REQUEST FOR PROPOSALS – ADDENDUM 1

ELECTRIC VEHICLE SUPPLY EQUIPMENT – MAY 2, 2025

Duluth Transit Authority

Addendum# 1

Figure 8- Breaker diagram for Chargers 5-8 (one run of 4 chargers). Another identical breaker panel serves chargers 1-4. However, the other breaker panel does not have anything in positions 14, 16, and 18, and those spaces appear blank. Circuit breakers are 80 A each.

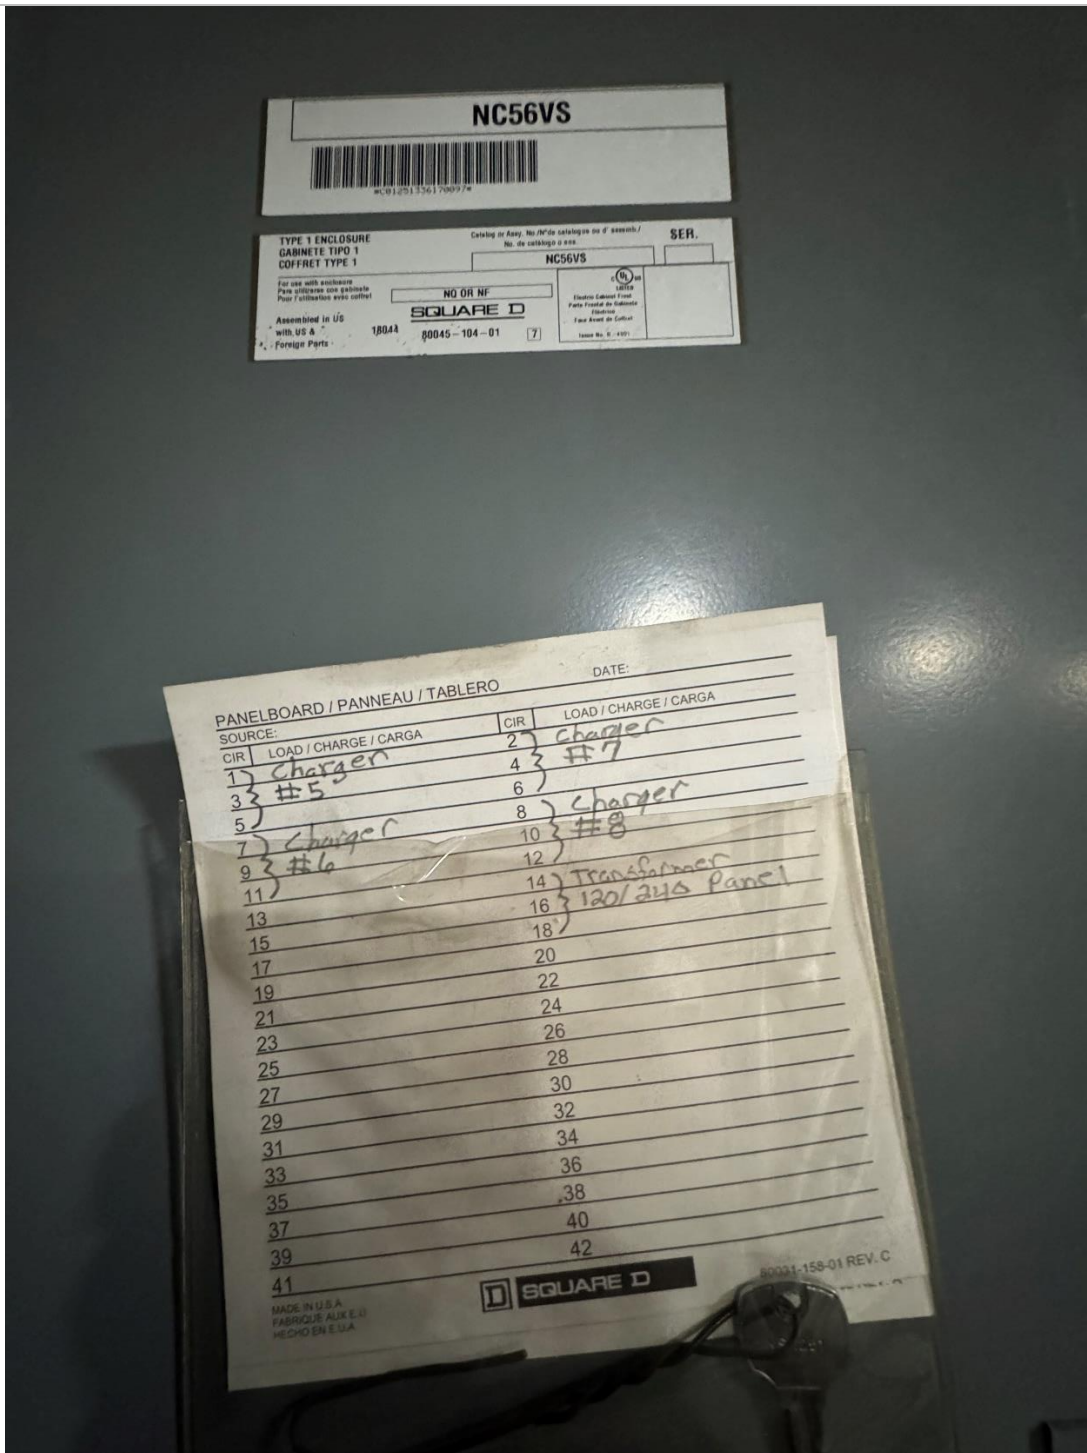
4	Can DTA provide the specifications of each sub-panel that serves the current EV chargers? (amperage rating, breakers, etc.)	Each of the two (2) breaker panels is rated to 800A. Currently, the circuit breakers supplying the EVSE are 80 A each. They can be upgraded to up to 125 A each without additional modifications upstream.
5	Can DTA provide detailed photos of each sub-panel that serves the current EV chargers?	See Exhibit A for site photos.
6	Can DTA provide detailed photos of the area surrounding the panels?	See Exhibit A for site photos.

13	Can your amperage capacity exceed 125a or is this dictated by upstream power (gear) limitations?	The existing panel will only allow up to 125 amp breakers. The DTA does not wish to make additional modifications to the infrastructure "upstream" of the breakers.
14	Would you be open to a power cabinet/separate dispenser architecture? This would require a power cabinet to be set near where the wooden crates are now.	The DTA will consider proposals using a "split system" or a centralized cabinet/dispenser setup, including those requiring installation near the wooden crates visible in the video, and shown in some of the photos in Exhibit A. If any additional equipment is needed, other than that explicitly specified in Section 6, for the Proposed EVSE to be installed, commissioned, operated, and supported to satisfy the DTA's and/or the manufacturer's specifications, it must be included in the proposal price and installation requirements described.
